# Microcontroller Technical Information

IE-703288-G1-EM1 In-Circuit Emulator Emulation Board for V850ES/SG1, V850ES/SG2, V850ES/SJ2, V850ES/SG3, and V850ES/SJ3 Usage Restrictions		Document No.	ZBG-CD-07-0019	1/2
		Date issued	March 30, 2007	
		Issued by	Development Tool Group Multipurpose Microcomputer Systems Division 4th Systems Operations Unit NEC Electronics Corporation	
Related documents	IE-703288-G1-EM1 User's Manual: U16697EJ1V0UM	Notification classification	√	Usage restriction
				Upgrade
				Document modification
				Other notification

Restriction No. 21 has been added. See the attachment for details.

No. 10 Bug in 16-bit timer M during break

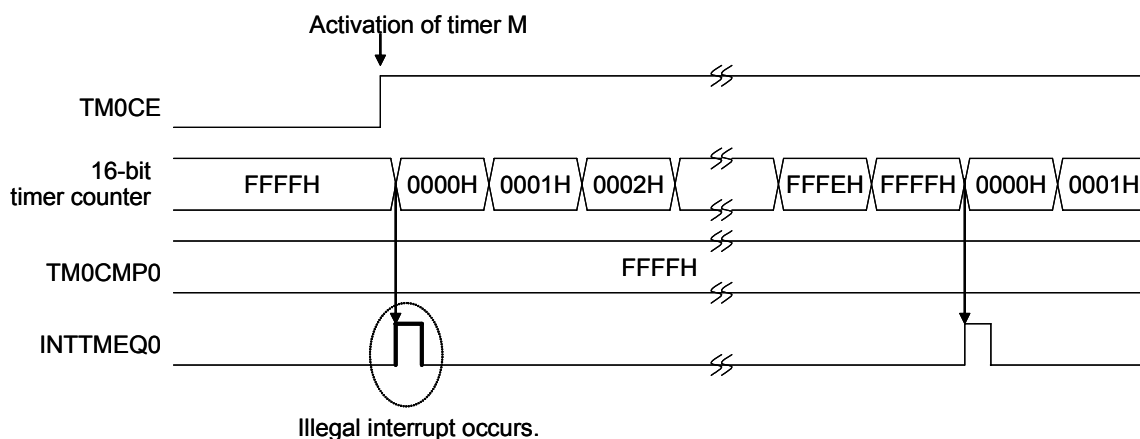
[Description]

When a break occurs while the following both (a) and (b) are satisfied, timer M does not stop even if the Peripheral Break function has been set to “Break”.

- (a) INTWLT, internal oscillation clock ( $f_R/8$ ), or subclock is selected as the source clock of timer M.
- (b) The main clock is stopped by setting the MCK flag.

Implement (a) or (b) below to stop timer M during a break using the Peripheral Break function.

- (a) Use the main clock ( $f_{xx}$ ,  $f_{xx}/2$ ,  $f_{xx}/4$ ,  $f_{xx}/64$ , or  $f_{xx}/512$ ) as the source clock.
- (b) Do not stop main clock oscillation.

Please regard this issue as a permanent restriction.
